## REVISED RESPONSE TO REQUEST FOR ADDITIONAL INFORMATION

### APR1400 Design Certification

Docket No. 52-046

RAI No.: 356-7881

Figure 7.5-2 QIAS-N Block Diagram

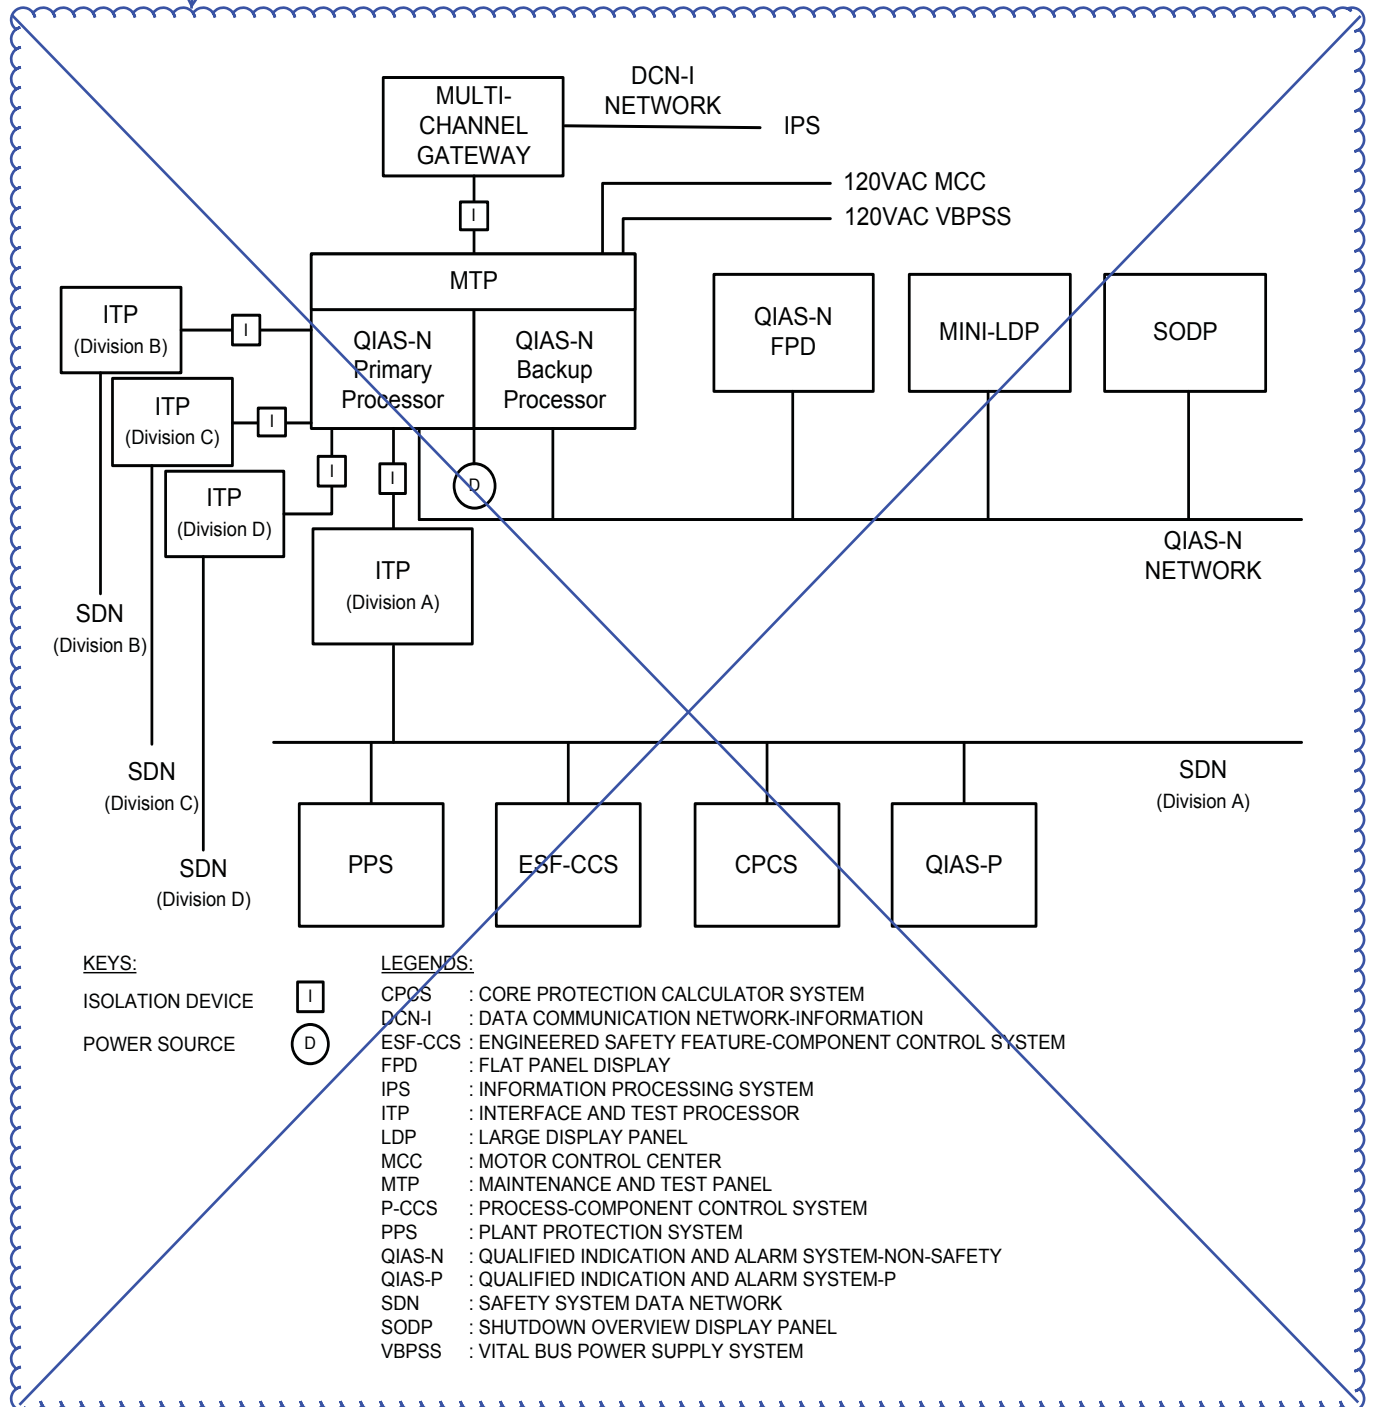
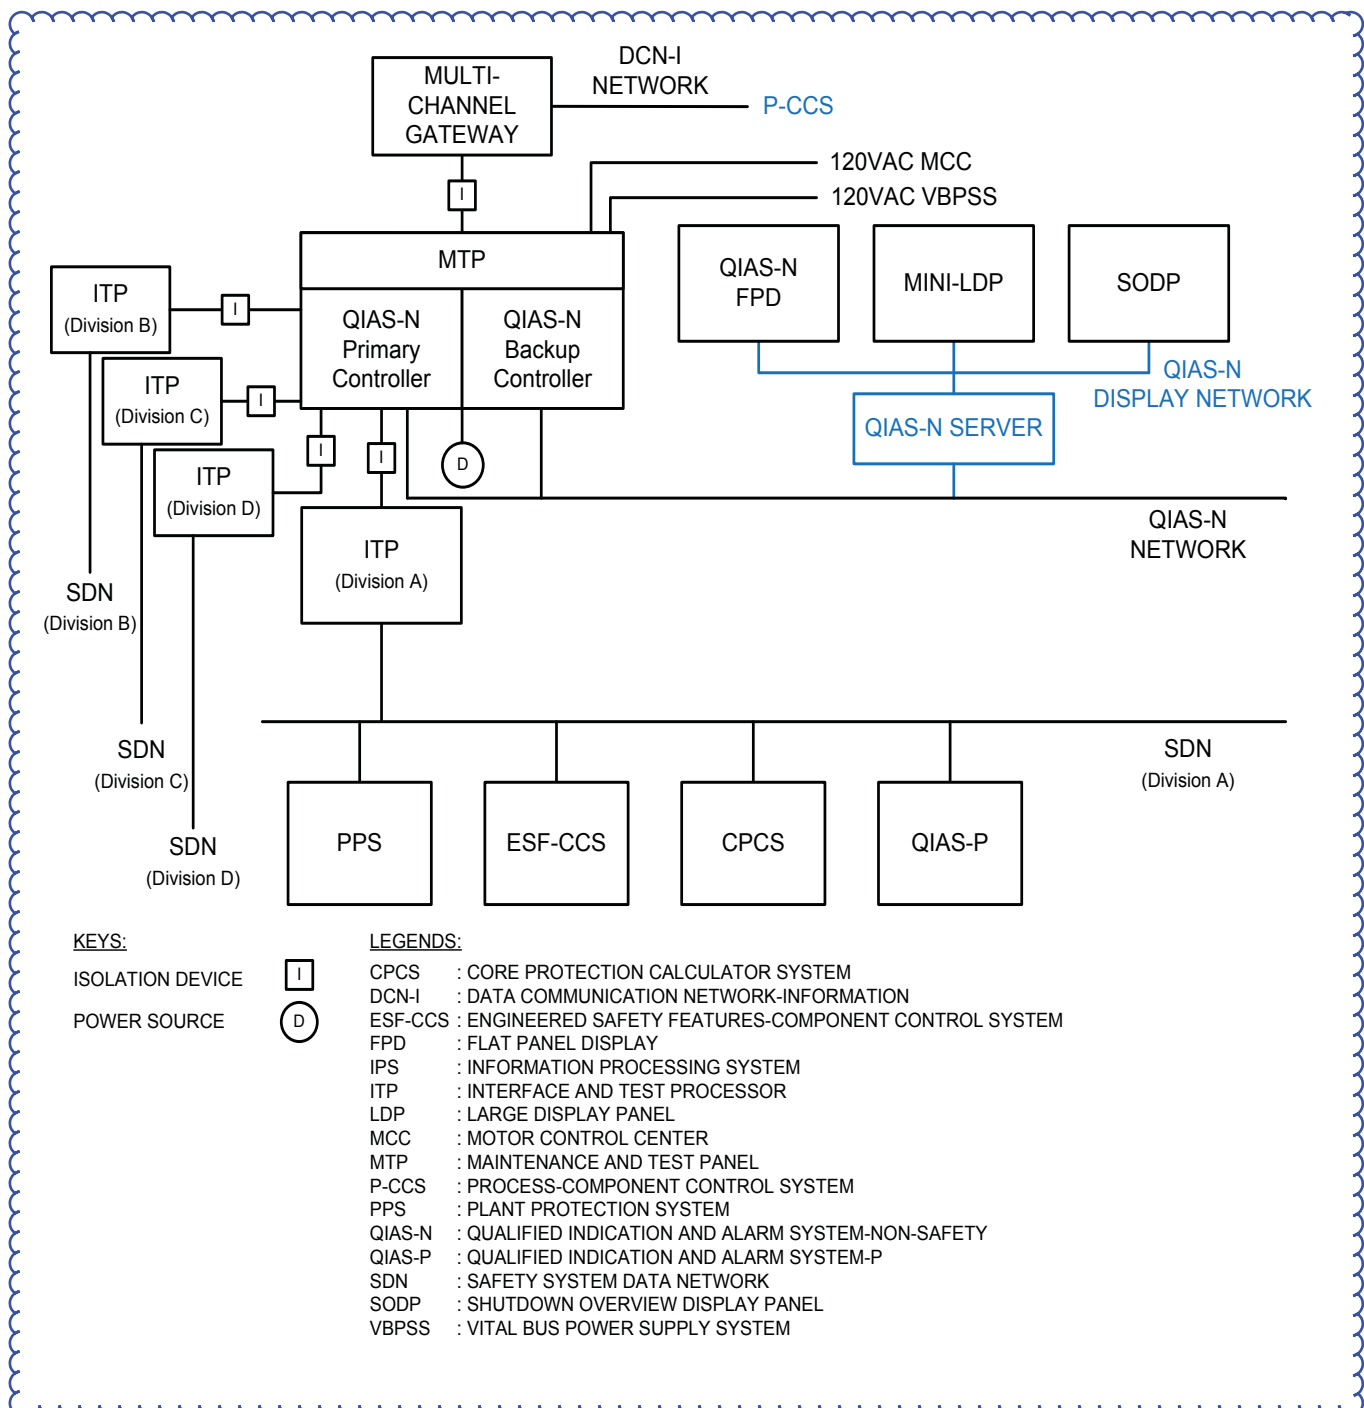
Describe the mechanisms, procedures, or processes in place for the APR1400 design that would allow operators to be alerted to a failure of either the QIAS-N or the IFPDs (e.g. frozen displays or controls).

The QIAS-N processor receives safety system signals via the ITP. The QIAS-N MTP receives non-safety system signals via the multi-channel gateway. Isolation devices are used between the ITP and QIAS-N processor, and between the multi-channel gateway and QIAS-N MTP. The QIAS-N processor performs applicable calculations based on the data received from the safety systems and non-safety systems. The QIAS-N MTP provides maintenance and testing means of the QIAS-N, and a gateway function with the multi-channel gateway to provide communication from the non-safety P-CCS. The QIAS-N server contains the process database, updates the values and status of the database records, executes the alarm processing function, and functions as a gateway between the QIAS-N network and QIAS-N display network.

The data from the QIAS-N processor (safety system signals) and the data from the QIAS-N MTP (non-safety system signals) are broadcasted on the QIAS-N network. The QIAS-N server captures the data from the QIAS-N network and updates the QIAS-N process database. The QIAS-N server broadcasts them on the QIAS-N display network for indication on the QIAS-N displays (QIAS-N FPDs, mini-LDPs, and SODPs).

In addition, the QIAS-N server provides system diagnostic functions as follows:

- a. Monitor the QIAS-N MTP, QIAS-N processor, QIAS-N network, QIAS-N display network.
- b. Detect QIAS-N trouble and generate QIAS-N trouble status signals.
- c. Transfer the QIAS-N trouble status to the non-safety IPS for alarm purpose.
- d. Transfer the QIAS-N trouble status to the QIAS-N MTP via QIAS-N network for indication on the QIAS-N MTP displays.
- e. Transfer the QIAS-N trouble status to the QIAS-N FPDs, mini-LDPs, and SODPs via QIAS-N display network.

This figure will be replaced with revised figure 7.5-2 on the next page.
